पत्रांक- 6519 / 12-1 देहरादून, दिनांक- 11 / 04 / 2025

विषय :- उत्तराखण्ड राज्य में राष्ट्रीय राजमार्ग संख्या-72 (झाझरा के पास) को दिल्ली-देहरादून एक्सप्रेस वे (आशारोड़ी सेक्शन के पास) से जोड़ने वाले चार लेन ग्रीनफील्ड रोड का विकास किमी 0.050 से किमी 12.220 तक निर्माण हेतु 20.0849 है० वन भूमि का गैर वानिकी कार्यों हेतु भारतीय राष्ट्रीय राजमार्ग प्राधिकरण को प्रत्यावर्तन।

(Online Proposal No.- FP/UK/ROAD/140350/2021)

PLAN
For
Wall fencing around the forest land
adjacent to the Proposed 4-Lane
Greenfield Road from NH-7 (Jhajhra) to
NH-307 (Asharori) to avoid any
encroachment and protect forest form
collateral damage

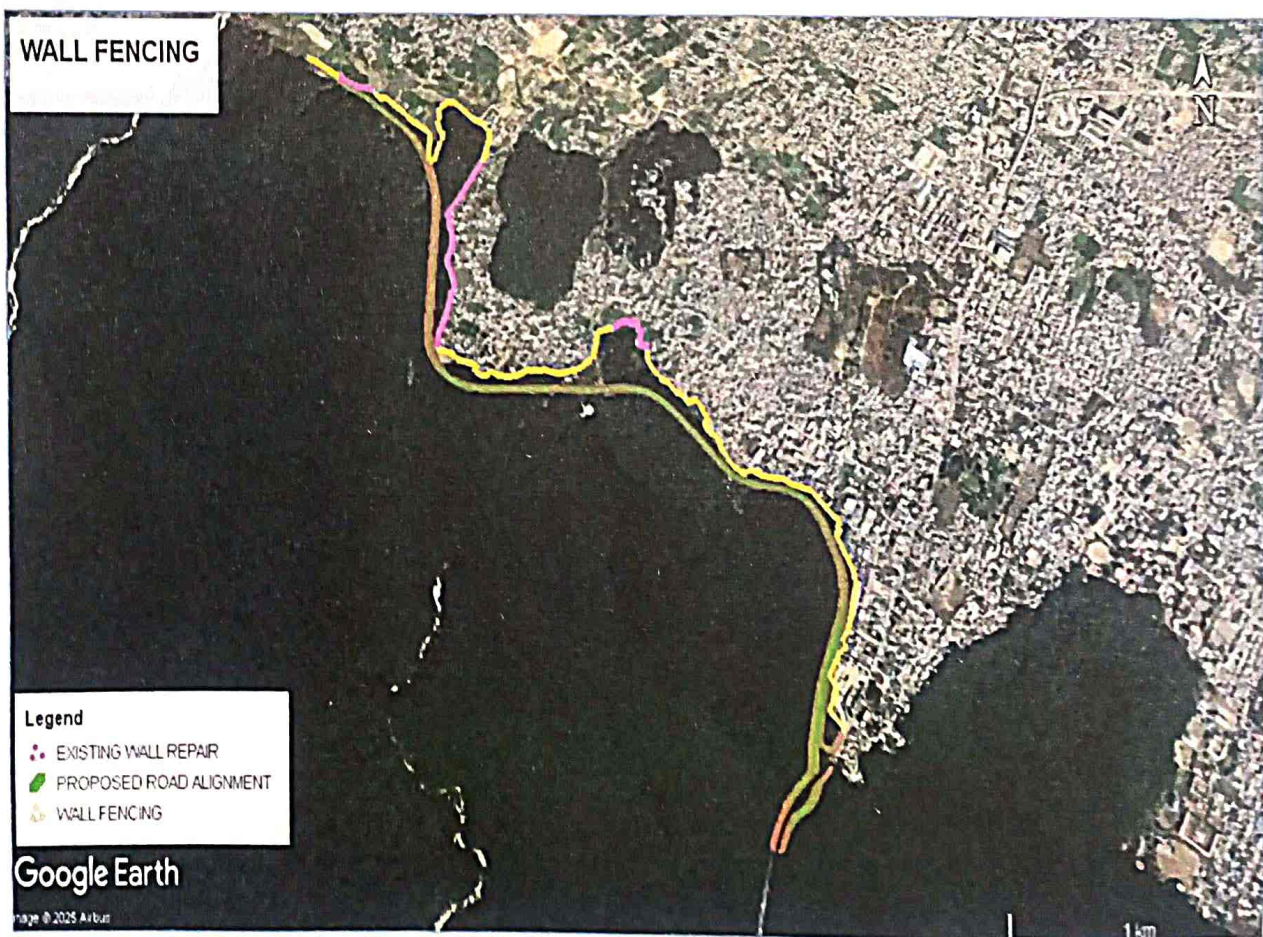
3.	The DFO Dehradun shall prepare a plan for fencing (wall fencing) around the forest land adjacent to the proposed road to avoid any encroachment and protect forest land from collateral damage. The cost of the proposed wall shall be borne by the user agency.	Reply to be submitted by DFO. Draft undertaking is attached.

This spatial arrangement poses a strong risk of future encroachment, unauthorized land use, and degradation of these isolated forest areas. To address this risk, a new brick wall of **5962 meters** and repair of **250 meters** of existing wall are proposed to act as physical boundaries for the protection of the forest land. The construction of this wall will ensure the long-term conservation of forest ecosystems and prevent encroachment activities in these vulnerable areas. This plan aligns with directive from the MoEF&CC's REC meeting and the cost of the proposed wall shall be borne by National Highway Authority of India (NHAI).

Construction of 5962 meters of new brick boundary wall and Repair of 250 meters of existing damaged wall:

- Wall height: **1.50 meters above ground**
- Foundation depth: **0.5 meters with 0.10 m PCC base**
- 230 mm thick brick masonry in cement mortar 1:3
- 15 mm cement plaster
- RCC Column Placed at regular intervals for structural support and resists lateral forces
